Action Needed On Implementation of Change #4 of Commit Request 4p7_4 and an Opportunity for Reducing Run Time

COM Commit Request Number 4p8_5

Hossein Shakiba

Huawei Technologies Canada

Change #4 of Commit Request 4p7_4 as Intended

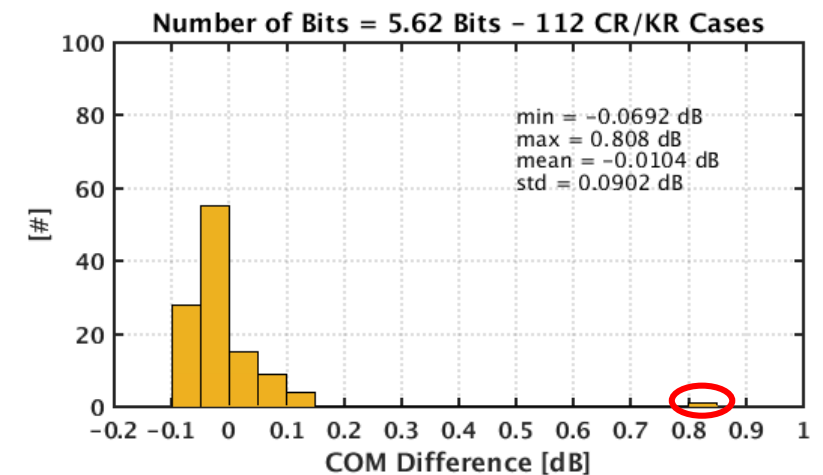
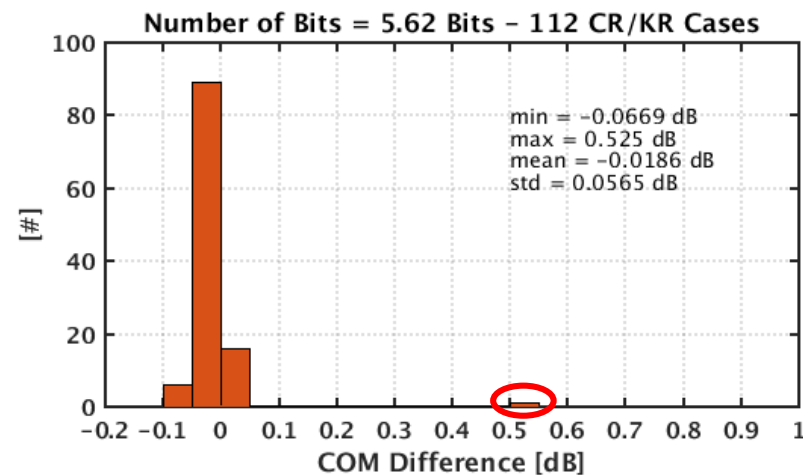
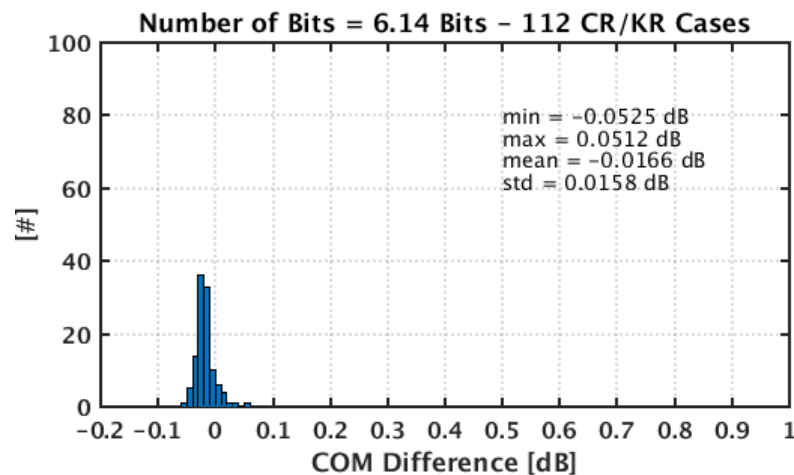
- Remove the old lines

Keep these lines

"s" should be "S"

Remove these lines

Remove duplicate lines

- Also implement the changes in **BLUE** to cleanup
